GFCI SENSING MODULE UPGRADE

GA9.7HEA

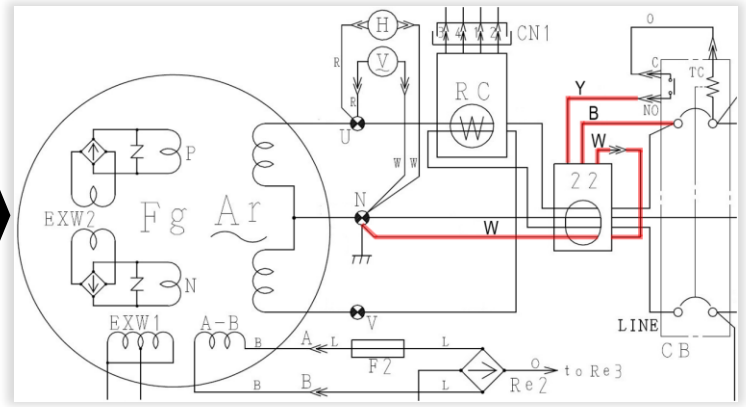
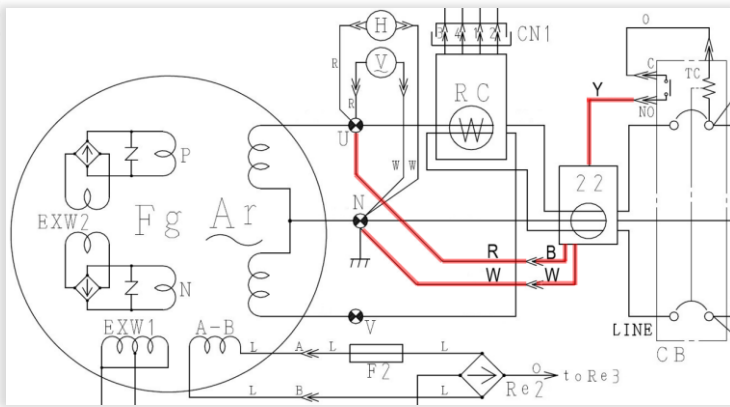
The affected models that use a yellow labeled GFCI with "Self-Testing" GFCI Sensing Module is incompatible with older models. These units may experience nuisance tripping of the GFCI opening the CB. The corrective action is to remove the YELLOW labeled module and install a Black labeled module, P/N 0601829302. When installing, some wiring modifications are required. Use the below diagrams to make the required changes. The change is to reposition the Blk wire from the terminal block to the CB. Contact MQ tech support for assistance.
